### **Architectural Control Committee**

## Changes being considered:

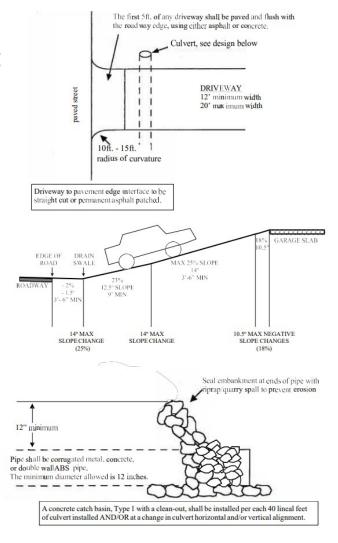
Fill with gravel (please see estimate in email file) We would like to fill in this area with gravel, so my wife can easily park her car. She is scared to park her car in the sloped driveway. She calls me (her husband) every time to properly park the car in our sloped driveway. It is dangerous in the rain and the winter, and we have three small children who we want to keep safe. This gravel filled area would help keep our family safe during the extreme weather in SV. This will not impact the drainage, it will only help my family. Contractor is licensed, insured, and bonded.

- These plans have been revised to meet ACC policies, with exceptions noted below:
- 1. The driveway slope is indicated at 26.8%, and the maximum driveway slope per the ACC policies is 25% without a variance. I have recommended the builder reduce the slope or submit a variance.

A maximum driveway slope shall not exceed 15%. A maximum driveway slope of up to 20% may be approved, dependent on the site, if the driveway is grooved or if other measures are taken to ensure that the driveway remains safe.

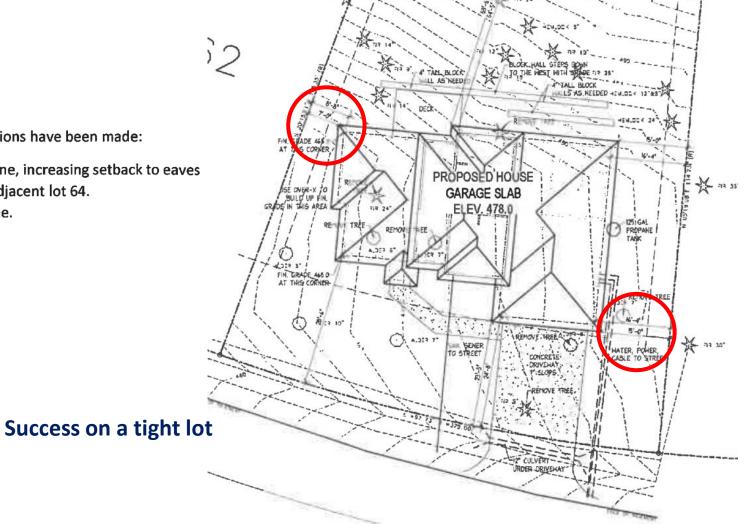
- House footprint has been moved away from east lot line, increasing setback to eaves from 6'-7" to 15'-0" in effort to protect the trees on adjacent lot 64.
- Additional retaining wall added to the rear of the home.
- Elevations pages show more accurate finished grades

Interior Side - At least Five (5) feet. Combined Interior Side setbacks must be at least twenty (20) feet.

## **Structure requirements - Hot Tubs** 14.6.7

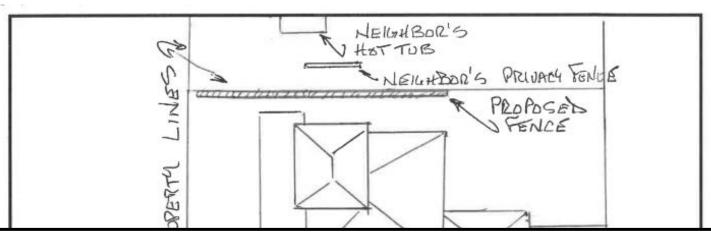
Give a full description, additional considerations, and attach additional information if needed:  PRIVACY FENCY IS REQUESTED A LONG SW PROPERTY  LINK, AS SHOWN, TO BLOCK NUTHHBOR'S HOT TUB (FULL VIEW)  DESPITE NUSHHBOR'S "PRIVACY FENCE") FENCY TO BE BULT ADP WAN
AC Staff Comments:  *NOTE: NEKHBOR USES HOT TUB WITHOUT CLOTHING, IN FULL VIEW FROM OUR DINING PLOOM & DECK. WE HAVE GRANDKIDS AND GUESTS WITH AHLDREN IN OUR HOME.

Hot tubs must be screened from view of adjacent properties and roads by a privacy panel or similar design consistent with the design of the main structure (house).
